# Access Compliance Report

## Public Rights-of-Way

### (Curb Ramps)

Intersection ID: 20205	Main Street: FAIRVIEW_RD	Cross Street: OLD_SAYBROOK_CT	Location: NW
ADA ID: 49367F64E906	Ramp Type: PerpDiag	Initial Pass/Fail: Fail	Overall Compliance: No
		Severity Score: 12.5

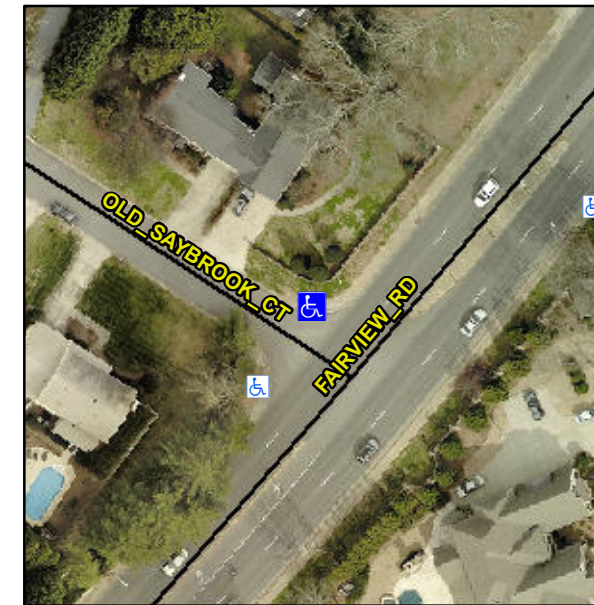
**R304.2.2**

Compliance	Description	Data	Compliance	Description	Data
N/A	Ramp Length (in)	60.0	No	Ramp Slope (%)	11.0
Yes	Ramp Width (in)	48.0	Yes	Ramp XSlope (%)	2.0
N/A	Flare Type LT	N/A	N/A	Flare Type RT	N/A
N/A	Flare Slope LT (%)	N/A	N/A	Flare Slope RT (%)	N/A
N/A	Flare Traversable LT?	N/A	N/A	Flare Traversable RT?	N/A
N/A	Landing Length (in)	N/A	N/A	DWS Provided?	N/A
N/A	Landing Width (in)	N/A	N/A	DWS Contrast?	N/A
N/A	Landing Slope (%)	N/A	N/A	DWS Length (in)	N/A
N/A	Landing X Slope (%)	N/A	N/A	DWS Full Width?	N/A
N/A	Landing Curb? (Y/N)	N/A	N/A	DWS Offset (in)	N/A
N/A	Shared Landing?	N/A			
N/A	Gutter Ponding?	N/A	N/A	Gutter Slope (%)	N/A
N/A	Gutter Lip Ht (in)	N/A	N/A	Gutter X Slope (%)	N/A
N/A	Painted X Walk1?	No	N/A	Painted X Walk2?	No
	X Walk 1 Direction	To SW		X Walk 2 Direction	To SE
N/A	X Walk 1 Width (in)	N/A	N/A	X Walk 2 Width (in)	N/A
	X Walk 1 Slope (%)	0.4		X Walk 2 Slope (%)	1.9
	X Walk 1 X Slope (%)	2.2		X Walk 2 X Slope (%)	0.5

**Remove & Replace Curb Ramp With Two New Directional Ramps or Equivalent.**
